GATSBY'S PATIO AND FAÇADE RENOVATION JSP24-14

Public hearing at the request of Tower Built LLC for Special Land Use and Preliminary Site Plan approval for the exterior renovation of the existing Gatsby's Restaurant. The subject property is approximately 1.09 acres and is located at 45701 Grand River Avenue, on the south side of Grand River Avenue and west of Taft Road in the I-1, Light Industrial District.

PLAN REVIEW CENTER REPORT

Review Date: July 30, 2024
Review Type: Preliminary Site Plan Review
Project Name: **JSP24-14: GATSBY'S PATIO**
Location: 45701 Grand River Ave; South of Grand River Ave, West of Taft Rd
Plan Date: June 25, 2024
Prepared by: Lindsay Bell, AICP, Senior Planner
E-mail: lbell@cityofnovi.org **Phone:** (248) 347.0484

TITLE: SITE PLAN

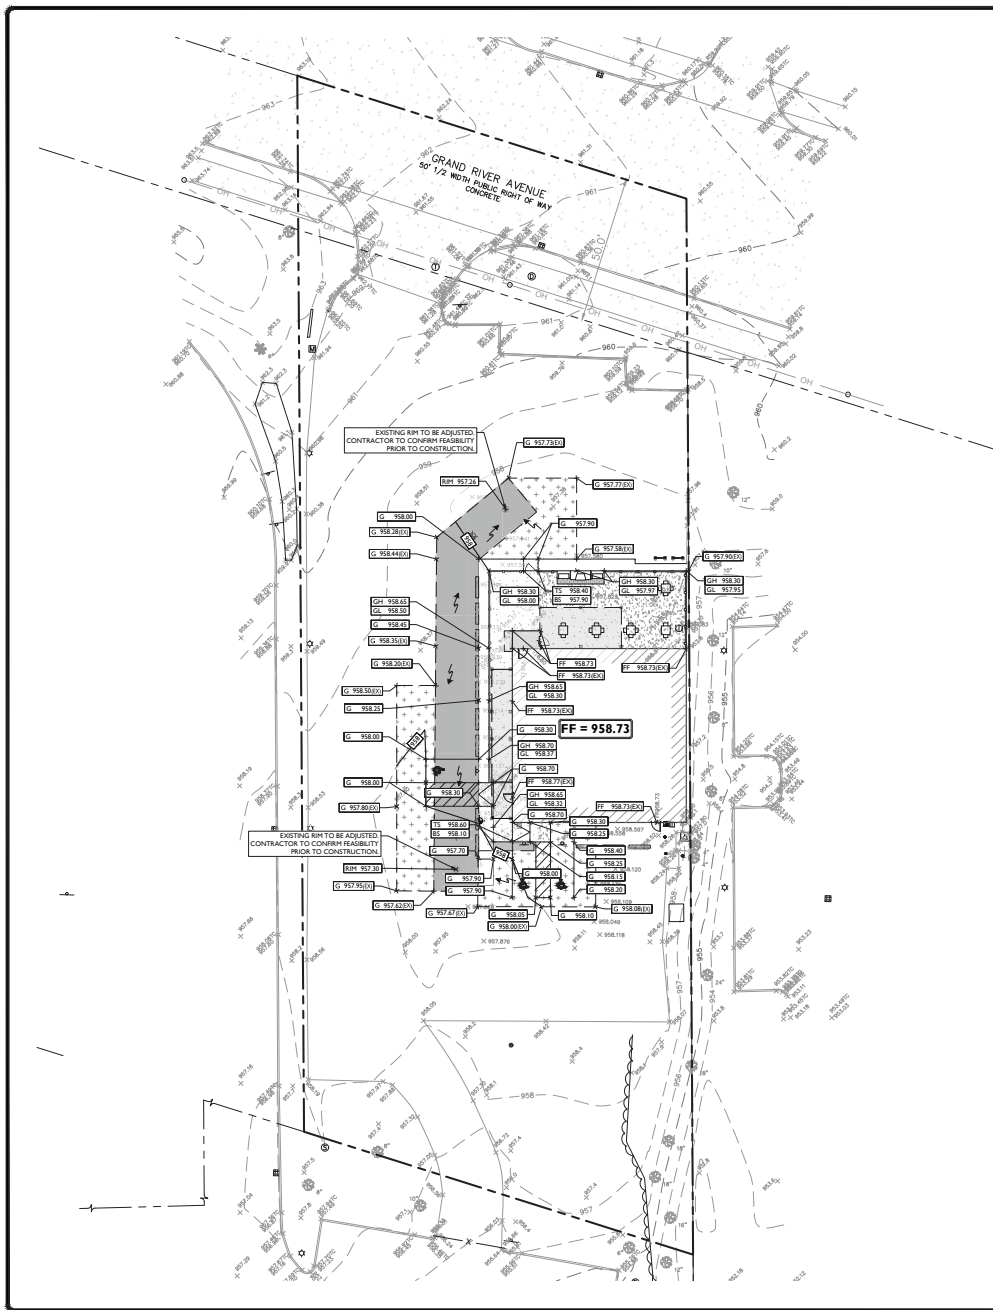
1. Outdoor Seating Requirements (Sec. 4.84): If the seating area is proposed as part of a site plan application it shall require site plan review and approval by the Planning Commission. Once initial approval has been granted by the Planning Commission, City Council or administratively, as applicable, it may be renewed annually by the Building Official, provided that it complies with the original approval. In addition, please provide the following with the next submittal:

- a. **Provide a note or response indicating that the outdoor seating area will comply with the seasonal requirements:** "Outdoor seating shall be permitted between March 1st and November 30th with all furniture and fixtures including, but not limited to, tables, chairs and waste receptacles removed from the exterior premises after November 30th."

- b. **A layout and details for the patio seating must be provided at the time of Final Site Plan submittal in order to verify the following: compliance with building and fire codes, and chairs and tables shall be of quality durable materials such as metal or wood.**

2. Parking (Sec. 5.2): The number of required parking spaces to accommodate the building's use is currently unknown. The site plan proposes 64 parking spaces on-site. **Please provide the number of employees, building capacity, proposed patio capacity and square footage to verify the parking count. If the number of parking spaces is not sufficient to meet Ordinance requirements, the plans will need to be modified, or request a variance from the Zoning Board of Appeals.**

3. Bicycle Parking (Sec. 5.16): Currently, the site appears to not have any bicycle parking. Based on the 64 parking spaces provided, 3 bicycle parking spaces are required. **As the restaurant is being enlarged by more than 10%, this requirement must be met. If the applicant does not agree to provide the required spaces at the time of Final Site Plan, a variance must be requested from the Zoning Board of Appeals.**
4. Planning Chart: Please refer to the attached Planning Chart for additional comments to address in the next submittal.

A note has been provided on Sheet C-3 of the Site Development Plans.

A layout of the proposed seating has been provided on Sheet C-3 of the Site Development Plans.

The maximum occupancy of the existing building is 124 people, and there are 7 employees during a maximum shift. The proposed 1,679 SF outdoor seating area shall have 20 seats. Per section 4.84.6 of the Zoning Ordinance, outdoor seating areas with 20 or fewer seats do not require additional off-street parking. 66 Parking spaces are proposed where 66 spaces are required. Refer to the Off-Street Parking Requirements table on Sheet C-3 of the Site Development Plans.

Two (2) bike racks, providing 4 bicycle parking spaces, are proposed at the northwest corner of the building. Refer to Sheet C-3 of the Site Development Plans.

The width of the pathway within the outdoor seating area has been dimensioned. A note stating the proposed tables / chairs shall comply with all applicable standards is provided on Sheet C-3 of the Site Improvement Plans.

A note stating 4" wide yellow pavement striping has been added to the proposed end island markings. Refer to Sheet C-3 of the Site Development Plans.
